RE: Field Issue of omission of top plate above daylight window header and omission of double joists under kitchen island for Lot # 87 Manor at Stoney Creek – 4409 SW Alabaster Circle Lee's Summit, MO 64082 – Permit # PRRES20210595

This letter addresses the omission of top plate above daylight window header and omission of double joisting under kitchen island for 87 Manor at Stoney Creek.

DAYLIGHT WINDOW

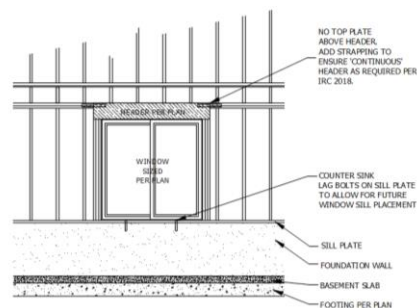
- It is structurally acceptable to omit the top plate above daylight window header per IRC R602.3.2:
 - Omission of top plate is permitted over headers where the headers are adequately tied to adjacent wall sections in accordance with Table R602.3.2.
 - Strapping shall be 3' x 12" x 0.036" galvanized steel plate or equivalent with (12) 8d box (2-1/2" x 0.113") nails connecting top plate to header.

R602.3.2 TOP PLATE. EXCEPTION:
 ".....THE TOP PLATE MAY BE OMITTED OVER LINTELS THAT ARE ADEQUATELY TIED TO ADJACENT WALL SECTIONS WITH STEEL PLATES OR EQUIVALENT....."
